MFN 06-274  
Supplement 1

**Subject: Response to Portion of RAI Letter Number 20 Related to ESBWR Design Certification Application – Seismic Design – RAI Numbers 3.7-16S1, 3.7-24S1, 3.7-30S1, 3.7-33S1, 3.7-35S1, 3.7-38S1, 3.7-39S1, 3.7-50S1, 3.7-54S1 and 3.7-57S1 – Supplement 1**

**Response to Portion of RAI Letter Number 20**

**RAI Numbers 3.7-16S1, 3.7-24S1, 3.7-30S1, 3.7-33S1, 3.7-35S1,  
3.7-38S1, 3.7-39S1, 3.7-50S1, 3.7-54S1 and 3.7-57S1**

**Figure 3.7-16 (1) Original Transfer Function for RBF in X Direction**

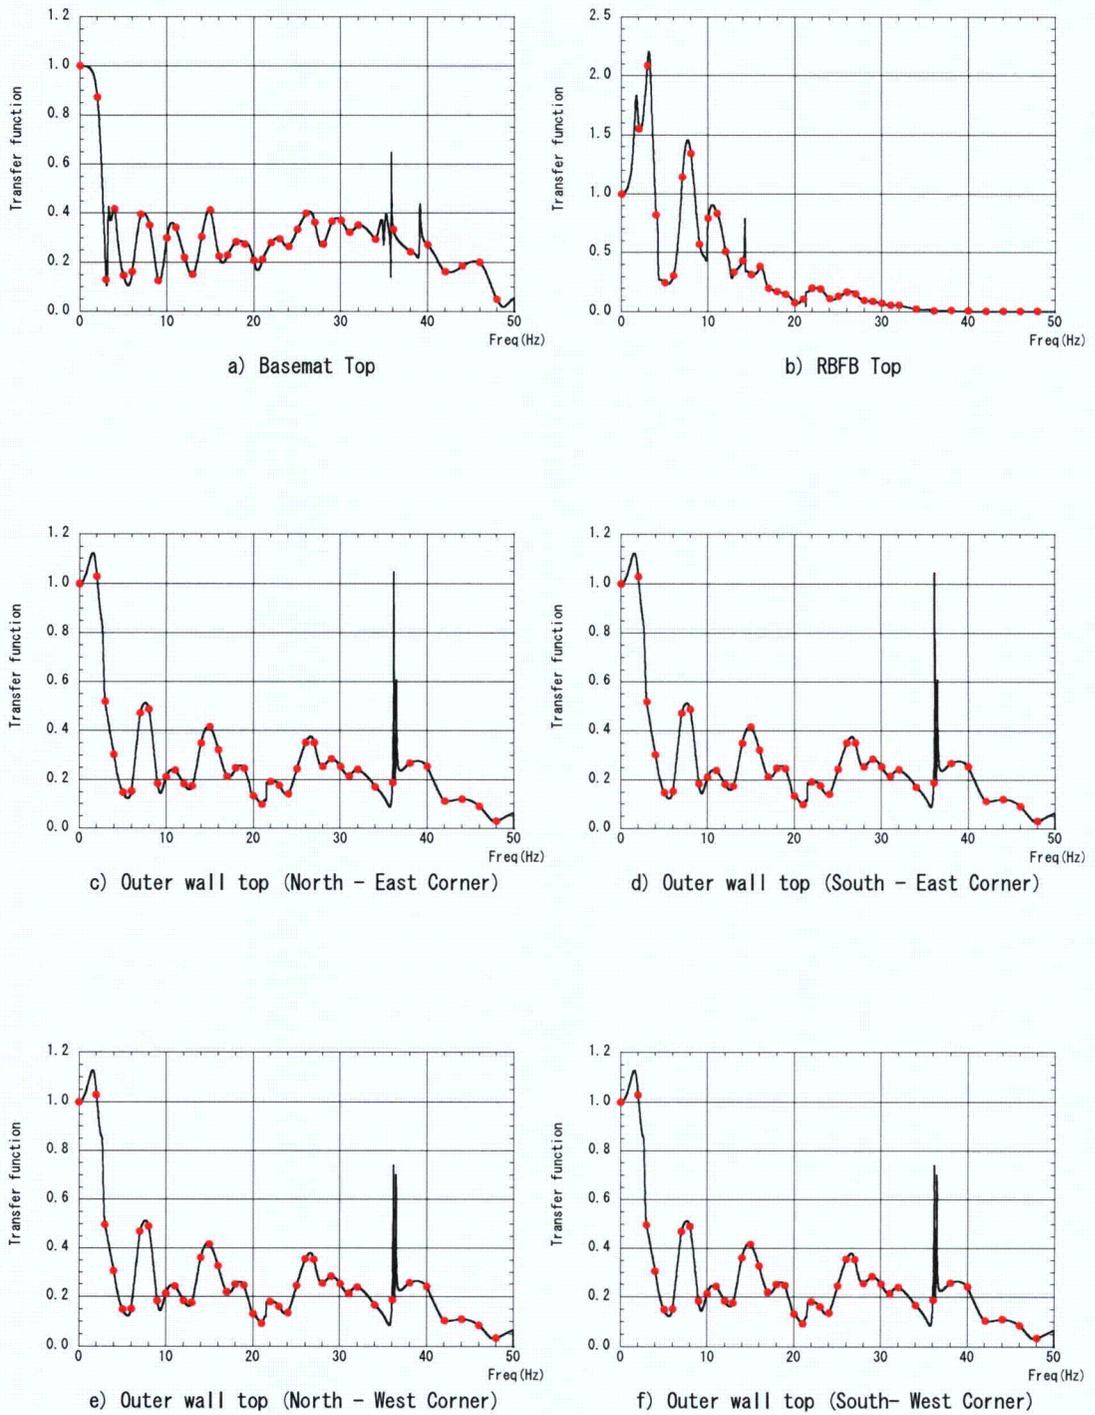
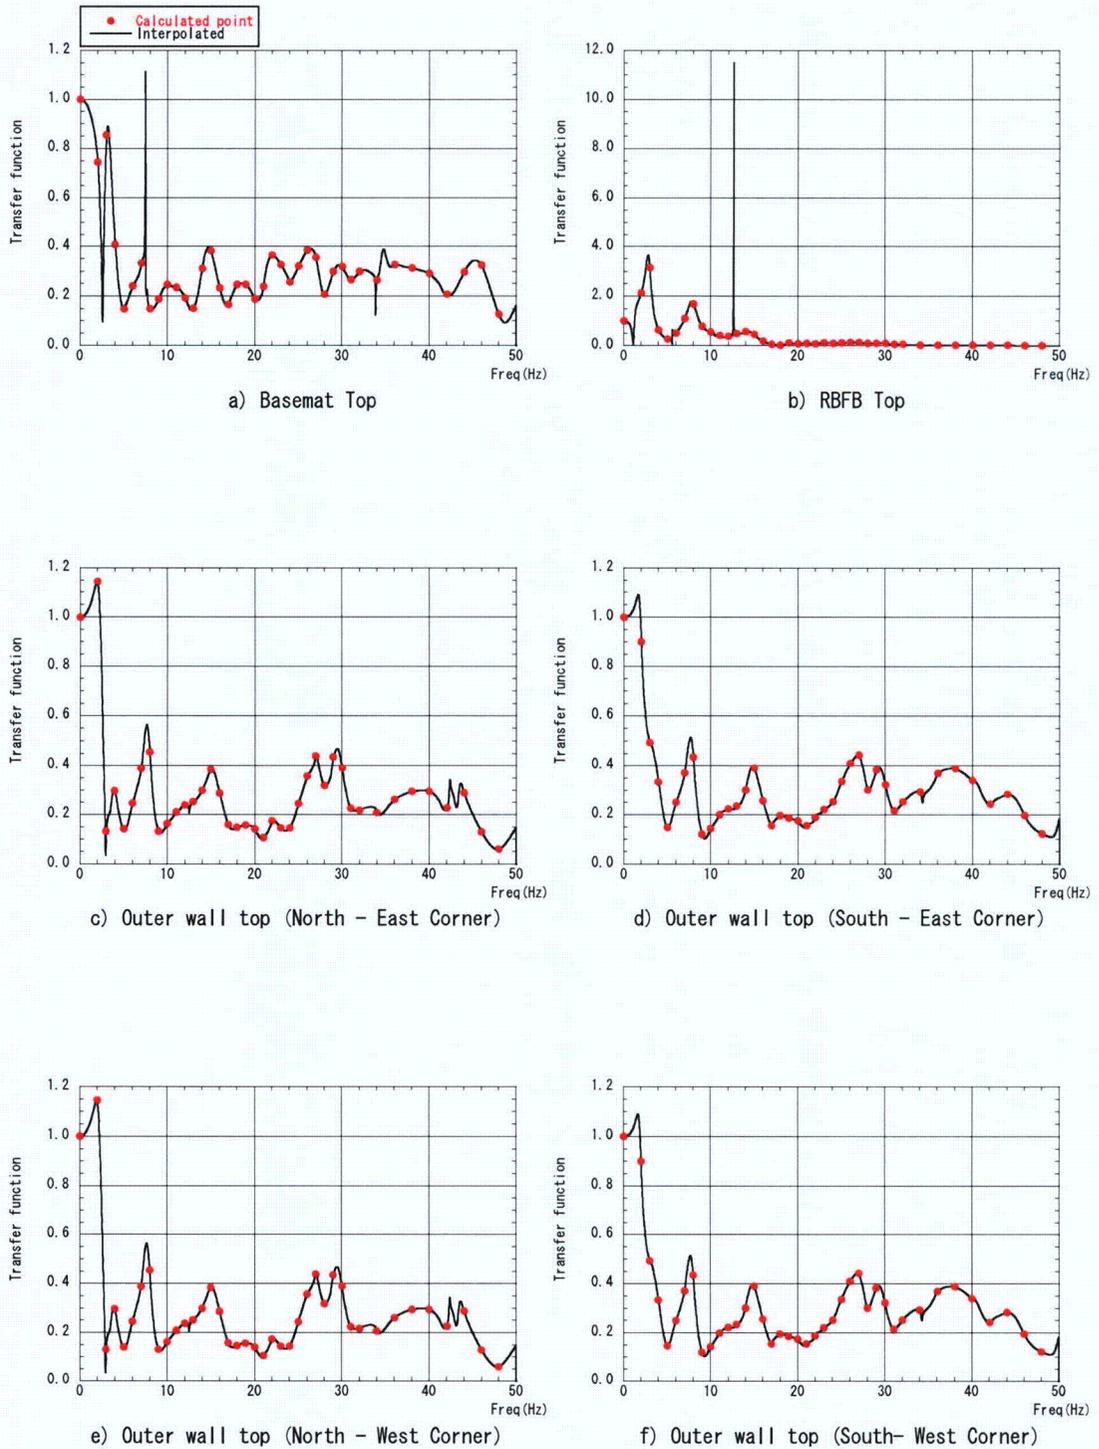
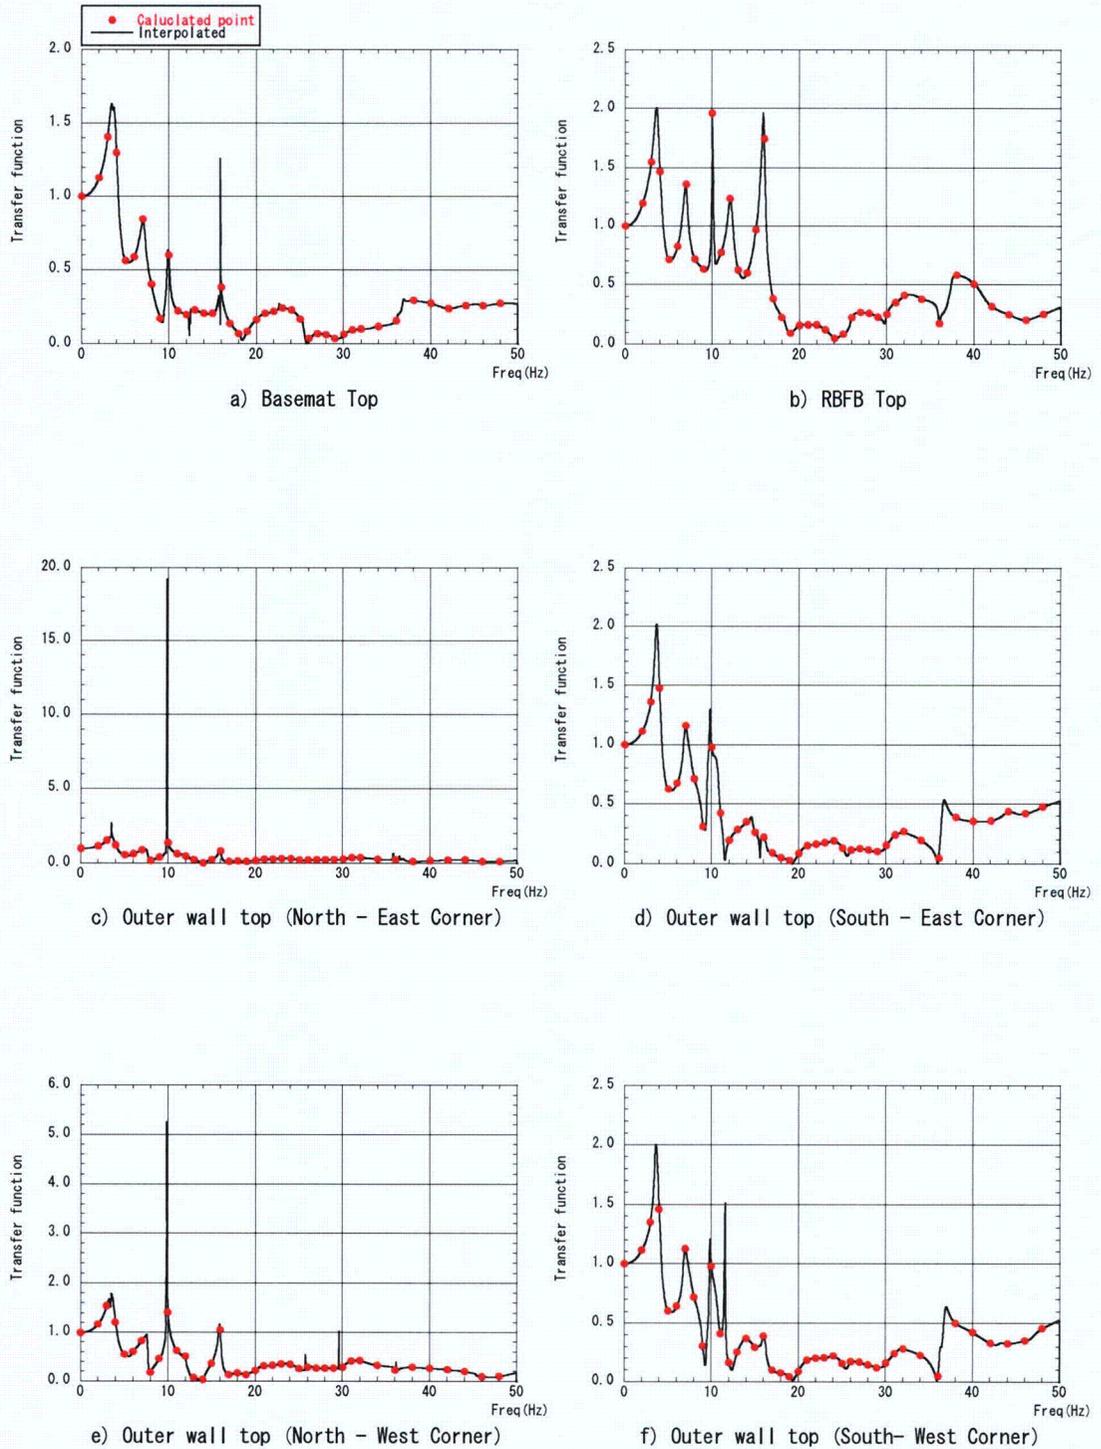
- a. *NRC staff consultants (BNL) to compare the results of their confirmatory analysis at the top of the CB and the top of basemat against the GE design spectra.*
- b. *Provide for the RB, a smooth plot of the transfer functions at the top of the building, top of the basemat and at the top of the four corners of the embedded walls.*

Figures 3.7-16 (1) through 3.7-16 (3) show the original transfer functions at the top of the RBFB building, top of basemat, and at the four corners at the top of the embedded walls, in X, Y and Z directions respectively. The soil condition is the layered site case 1 shown in the response to RAI 3.7-30 provided under MFN 06-274.
